BOX HILL/ BOX HILL INDUSTRIAL PRECINCT

Water Cycle Management POST RE-EXHIBITION STRATEGY REPORT

Prepared for:
Department of Planning & Infrastructure

November, 2012

Figure 8.3
Box Hill/ Box Hill
Industrial Precinct

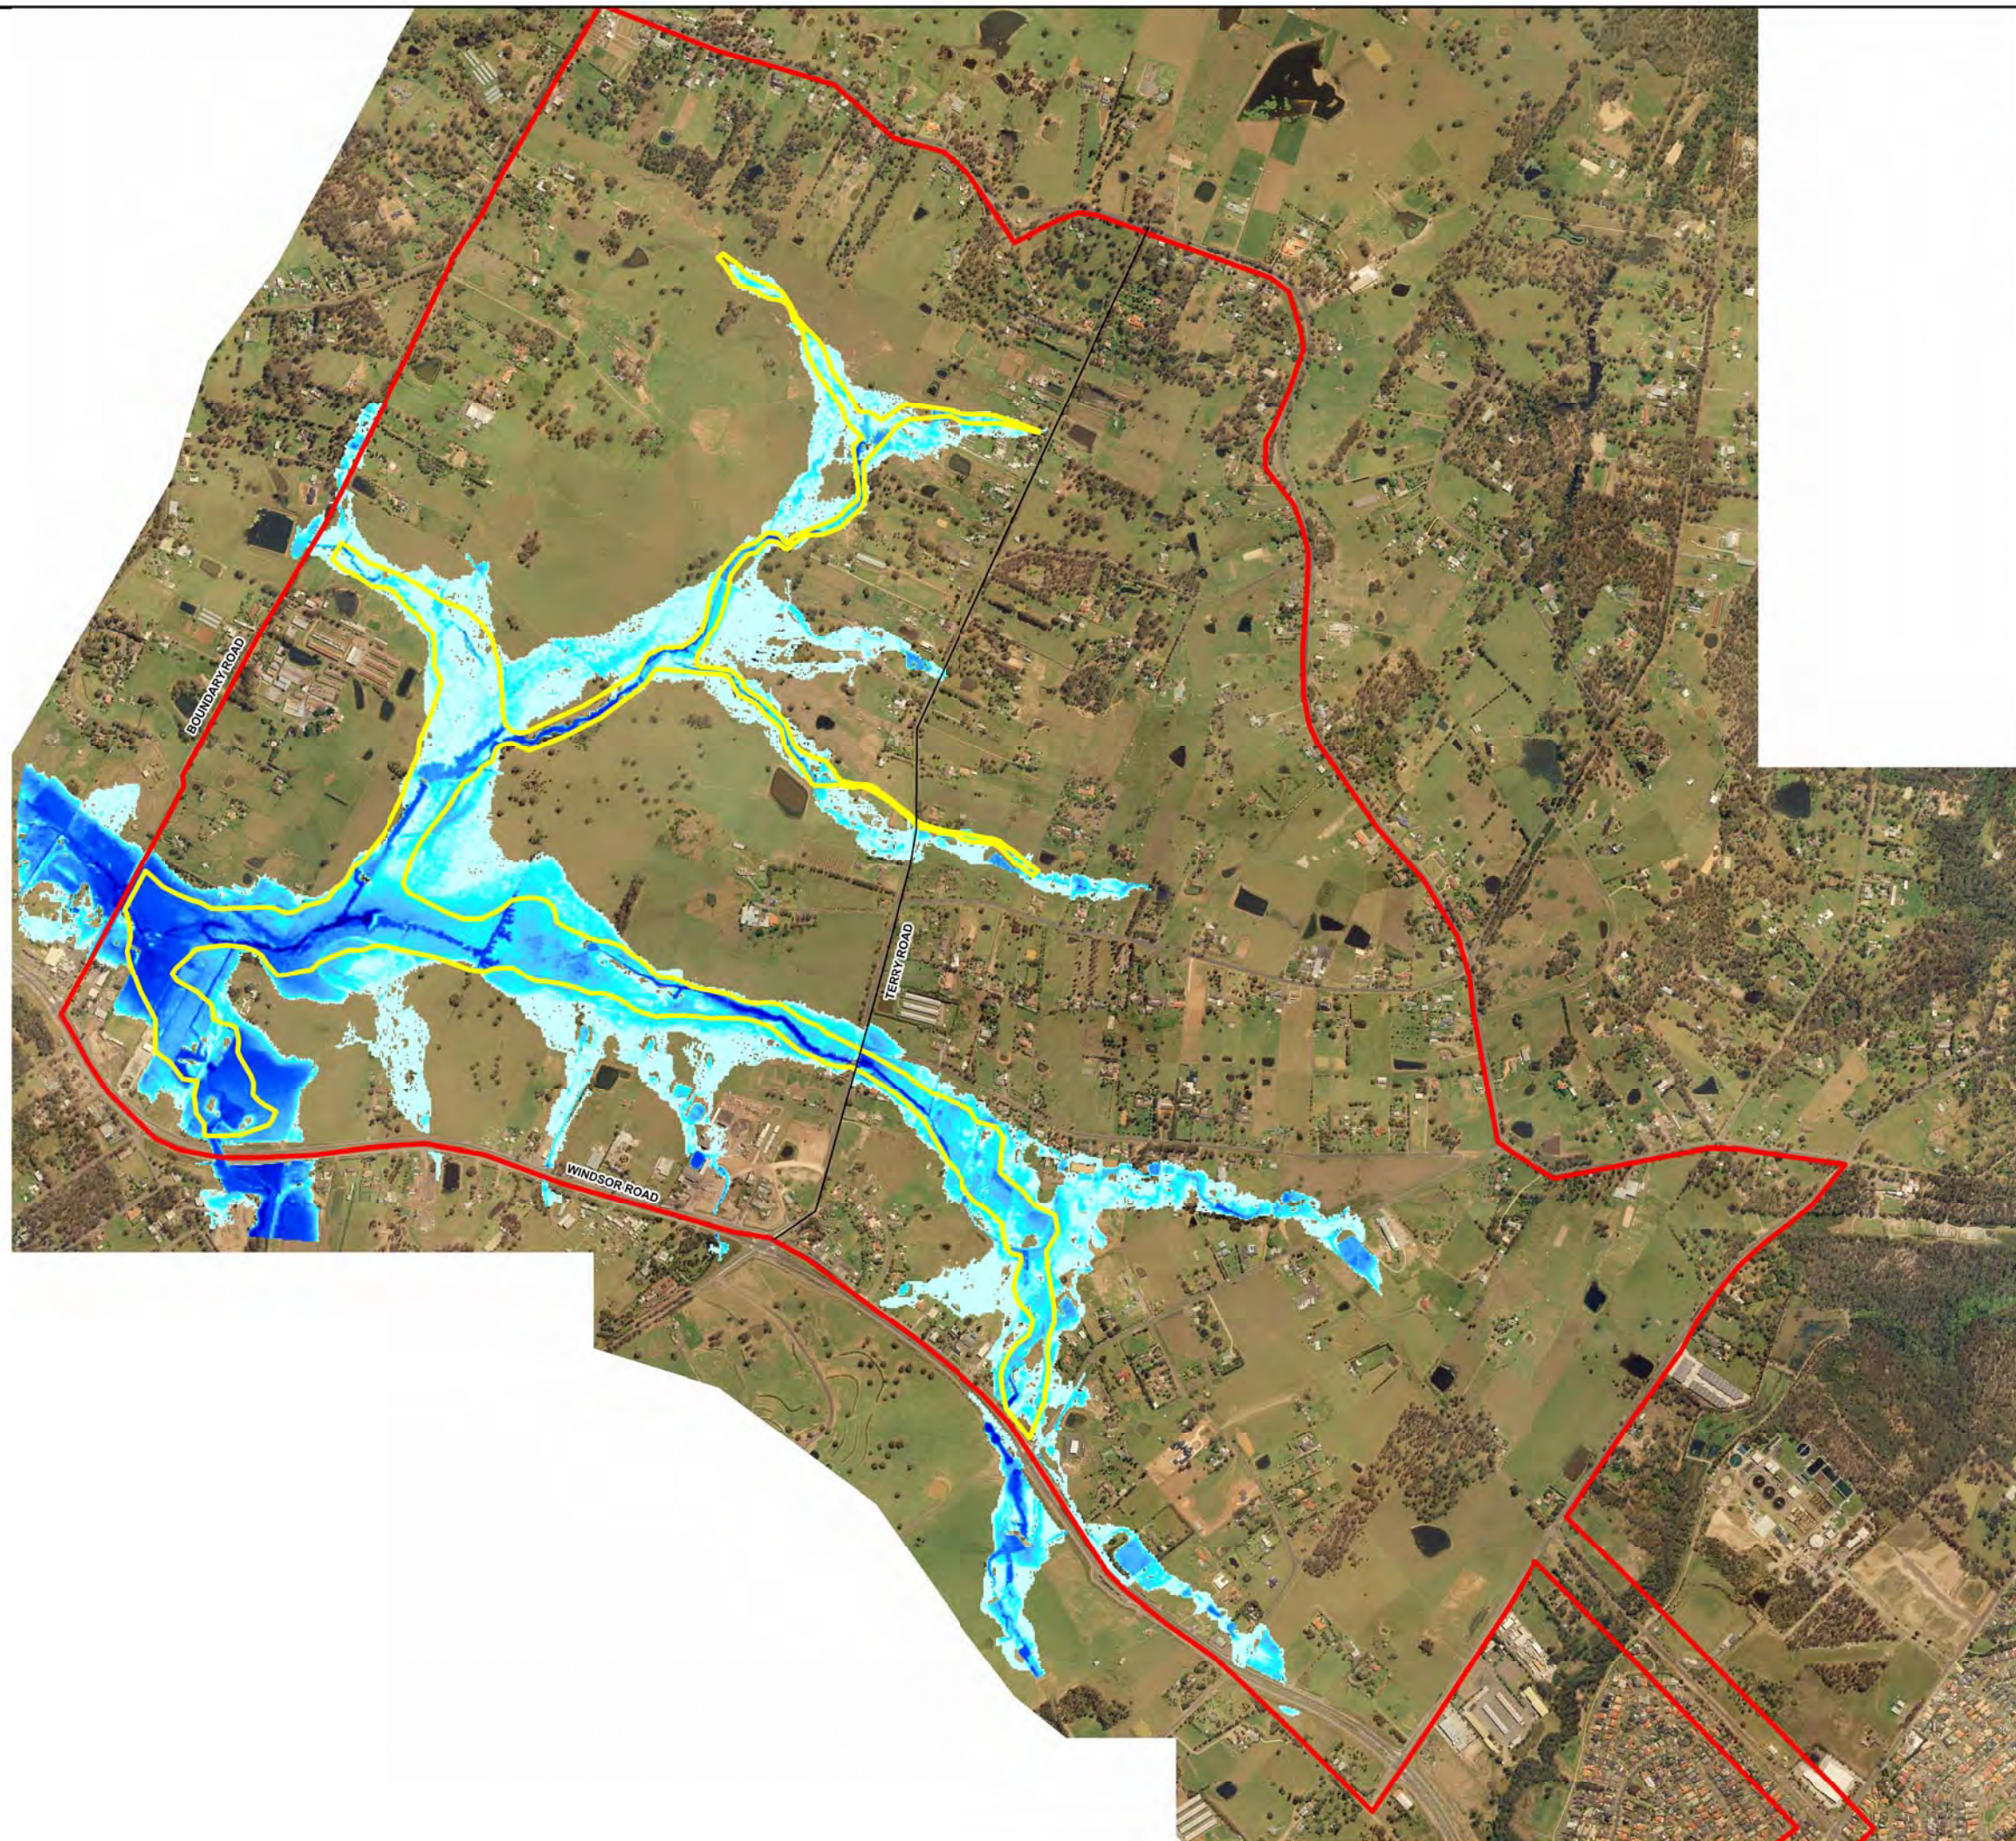
The NSW Office of Environment and Heritage recommends that “...flood storage also be determined for all flowpaths using a method consistent with the FDM and the 2007 Floodplain Risk Management Guidelines – Floodway Definition...”

We have indicated the Floodway extents on Figure 8.3 of the Post Exhibition Strategy Report (provided in Attachment A). It appears that OEH also requires an indication of areas defined as flood storage, in accordance with the relevant flood management guidelines.

The methodology required to determine flood storage areas is an iterative process which is considered unnecessary at the Precinct planning stage. Furthermore, The Hills Shire Council has agreed to the methodology adopted in the determination of the floodway within the Precinct as being suitable for this stage of the Precinct Planning process.

Figure 9.1
Box Hill/ Box Hill Industrial Precinct
Basin Servicing Strategy

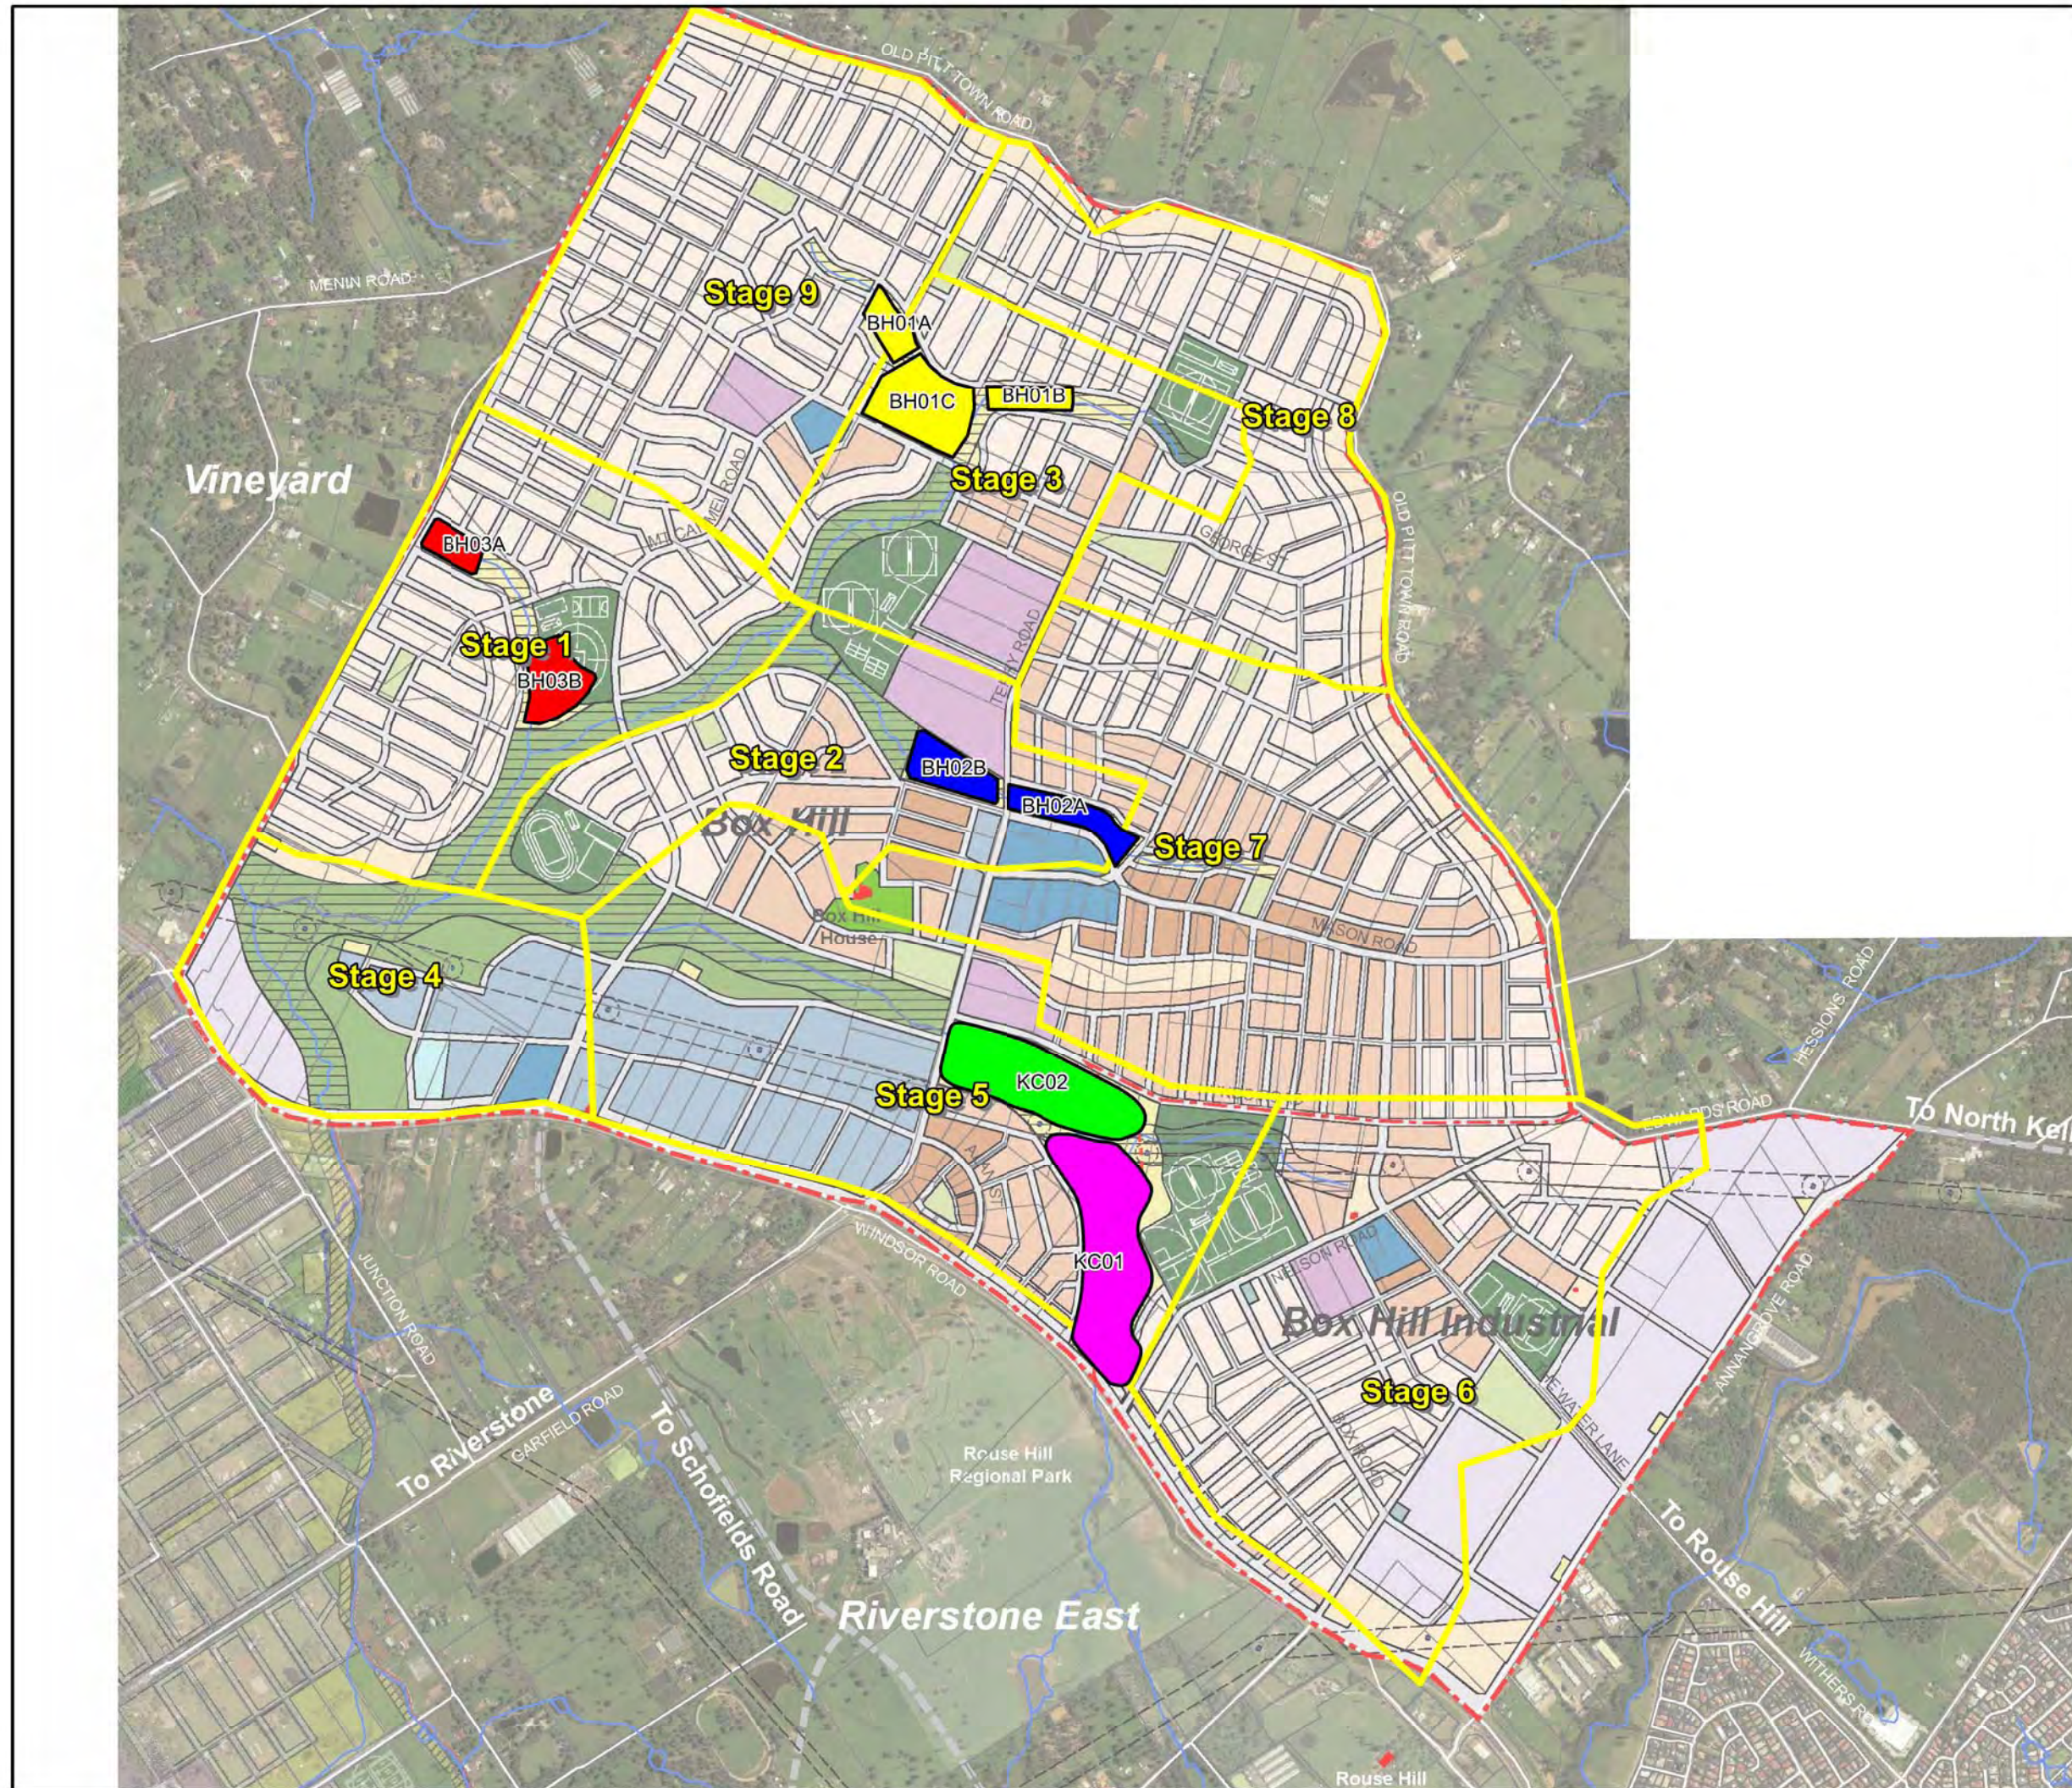
Recommendation that the staging plan is reviewed to include stages that can be “unstaged” outside the order as specified in the previous WCMP.

A submission has indicated that Stage 2 as defined in Figure 9.1 of the post exhibition Water Cycle Management Strategy (refer to Appendix A) has the potential to be constructed as an “unstaged” development without requiring regional basins to control discharge rates from the site.

JWP have undertaken a hydrological assessment and considered the development of Stage 2 in isolation and can confirm that 100 year ARI discharges **increase** at all points along the main watercourse downstream of the site as a result. Therefore, Stage 2 cannot be an “unstaged” development constructed in isolation without temporary detention devices being constructed to assist in managing discharges from the site.

Alternatively, Stage 2 may be developed independently if regional detention basin BH03B (within Stage 1) is constructed concurrently. Basin BH03B will provide sufficient detention for undeveloped upstream catchments to enable Stage 2 to release discharges without the requirement for an interim detention system.
